CITY PLANNING COMMISSION

- APPLICATION:**
- A. Negative Declaration
 - B. Special Permit modification to allow the relocation of a 300 foot high T.V. transmission tower
 - C. Gateway Center PUD Guideline Amendment to allow a 300 foot high tower on the subject site and delete the existing tower location
 - D. Gateway Center PUD Schematic Plan Amendment to allow a 300 foot high tower on the subject site and delete the existing tower location

LOCATION: 2213 Venture Oaks Way

PROPOSAL: The applicant is requesting the necessary entitlements to allow a 300 foot high T.V. transmission tower on the subject site.

EXHIBIT A

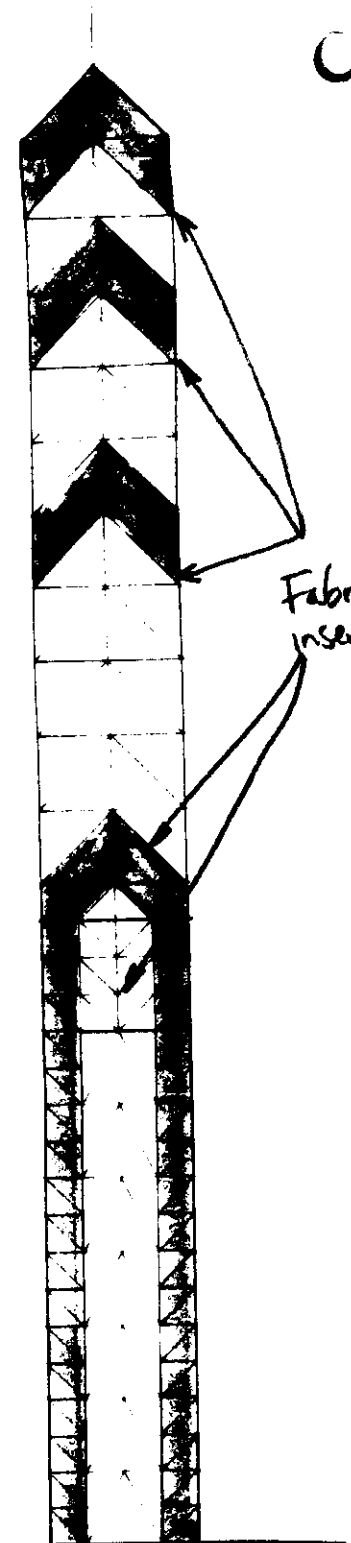
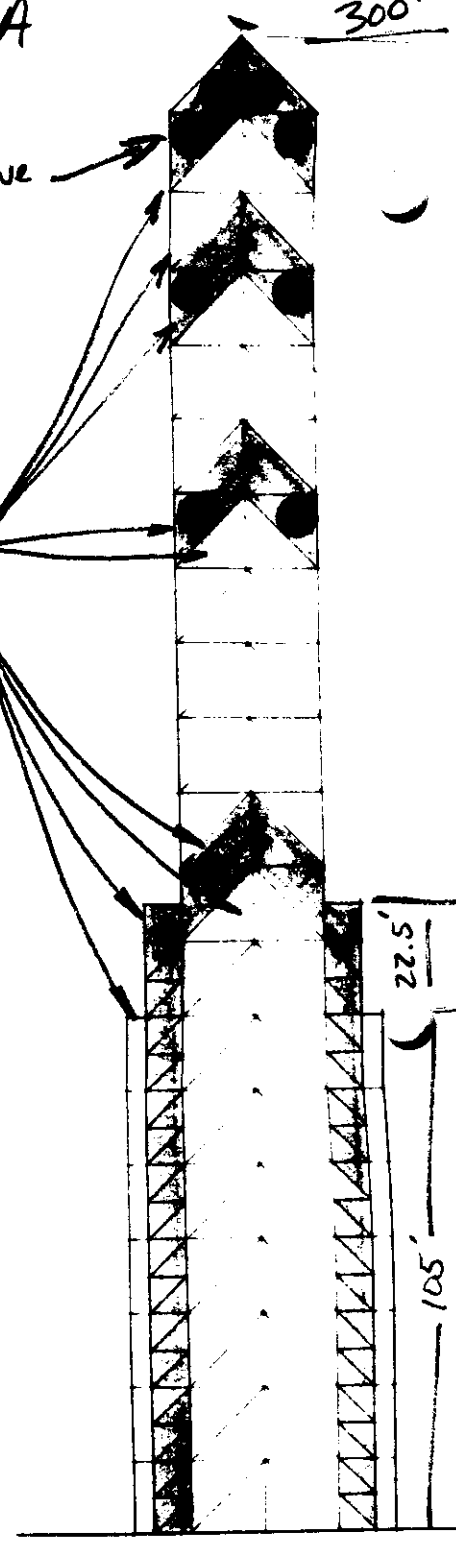
The applicant now proposes to locate a T.V. transmission tower on the T.V. station site. The proposed tower would be 300 feet high and constructed of tubular steel ranging from 20" in diameter at the base to 6" in diameter at the top. The applicant proposes to use colored (green and rust-pink) nylon fabric which will be attached at various heights on the tower to visually reduce the height and mass of the column. It is unknown at this time either how well or how long the nylon fabric will withstand the elements. The applicant is also unaware of any similar use on transmission towers within the U.S. (see Exhibit A).

Staff would object to the tower being located on the subject site since the MRD-PUD zone has no provisions for the construction of a T.V. transmission tower and because the PUD guidelines indicate that the tower should be located at the northerly edge of the PUD. Staff would not object to the new tower design so long as the design/materials is reviewed by the Design Review Board.

- C. Other Review: The Design Review Board must review and approve any changes to the design materials or color of the proposed tower.

EXHIBIT B
SCHEMATIC PLAN
 DEVELOPER: LEE C. SAMMIS COMPANY
 1951 RIVER ROAD, SUITE 100
 SACRAMENTO, CALIF. 95811
 LAND FILE: ANTHONY AND ASSOCIATES
 838 MONTELEONE BLVD.
 SAN FRANCISCO, CALIF. 94102

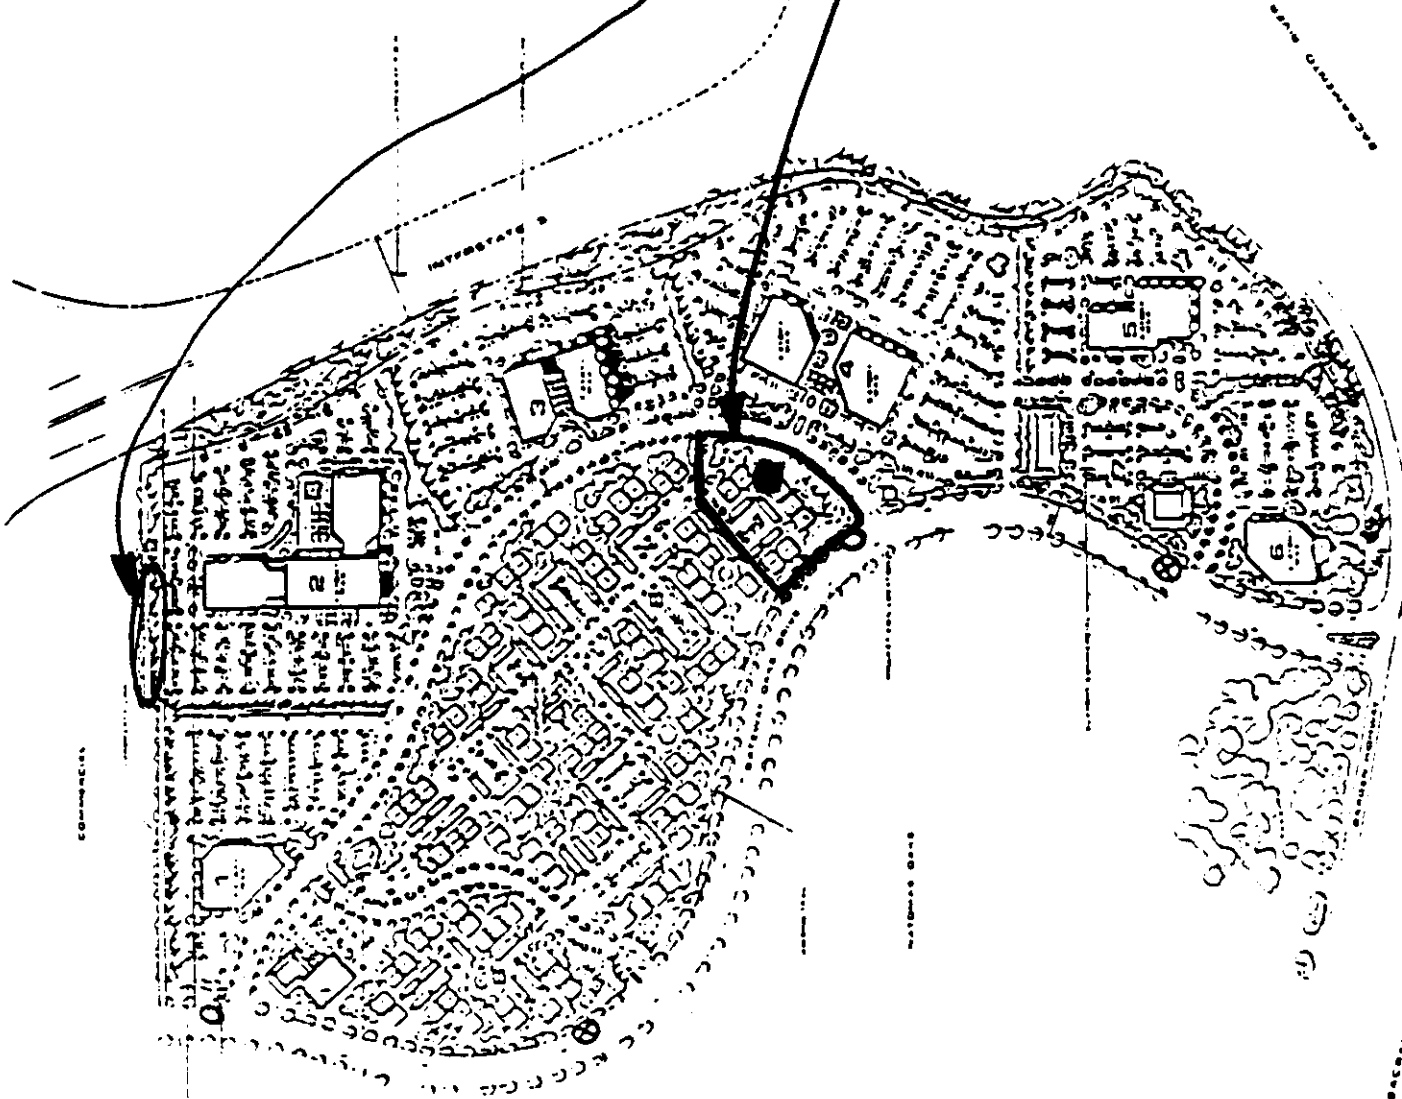
- B. Gateway Center PUD Guideline/Schematic Plan Amendment: The PUD Guidelines/schematic plan designate a communications tower and accessory communications equipment building to be located at the northerly edge of the PUD, either adjacent to or north of the existing utility towers (see Exhibit B). The applicant is requesting to amend the guidelines/schematic plan so as to allow a 300 foot high transmission tower and equipment building on the TV station site. The amendments would delete the existing approved tower site. The applicant's request has come about due to possible impacts upon the future shopping center site to the north of the existing tower site. The present request is to relocate the tower on the TV station site; however, the problem of impacts on adjacent land uses will not be solved.

Existing offices and residences are located on neighboring properties and would be impacted to a greater degree than if the tower were to be erected on the original site. The original site is located adjacent to lots which will in all likelihood be developed with shopping center (commercial) uses and offices. These uses can accept a greater degree of impact from adjacent uses than a residential use would be able to withstand. The original site is also presently developed with utility transmission tower which admittedly is some 200+ feet lower in height than the proposed T.V. tower. However, since the site was already developed with a transmission facility corridor and given the possible adjacent uses, planning staff recommended the original site in favor of a new site in the PUD. Staff recommends that the original site location be retained and that this application be denied as an inappropriate location for a T.V. tower site.

SITE PLAN

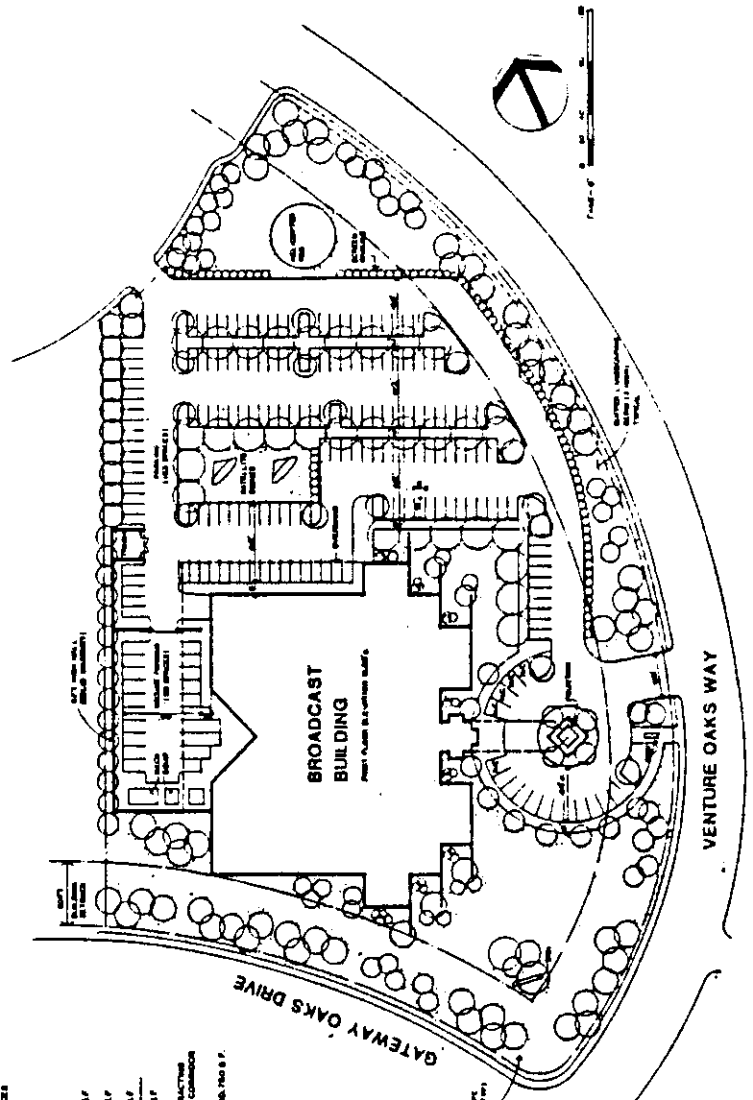
- F. Parking/Circulation: The applicant's site plan indicates that the parking calculations have been based upon the net square footage and not the gross square footage as is required by the Zoning Ordinance. The proposed broadcast facility contains 59,500 square feet of gross floor area which, at a ratio of one space per 250 feet of gross floor area, would require that 238 parking spaces be located on site. The site plan indicates that only 203 spaces have been provided, or 35 spaces less than required by ordinance. *Staff feels that the studio can be classified as a warehouse use which would require six parking spaces and reduce the overall parking to 216 or 13 more spaces than are provided on site. Staff feels that warehouse classification for the studios is appropriate only if both studios are utilized for non-audience participation programming. In the event that an audience participation shows are broadcast from either studio, then parking must be calculated at a higher ratio. (staff added)*

It appears that the handicapped parking spaces shown on the site plan will not meet code. All handicapped parking must be redesigned and/or relocated so as to comply with all applicable standards.

As proposed, a corner of the building would extend into the height restricted area along Gateway Oaks Drive. Staff recommends that the site plan be revised to locate the building outside of the height restricted area or at least that portion of the upper floors of the building which are greater than 25 feet in height.

1. A revised final site plan, detailed landscape and irrigation plans shall be submitted to the Planning Director for review and approval, prior to issuance of building permit, which incorporates the following changes:

- a. detailed landscape plan for the entire project site;
 - b. four-foot high berms along the street frontages;
 - c. relocation of the building so that it does not encroach into the height restricted area along Gateway Oaks Drive;

- d. 238 on-site parking spaces and 12 bicycle storage lockers.
2. The trash enclosure facilities shall be constructed in accordance with the following criteria:
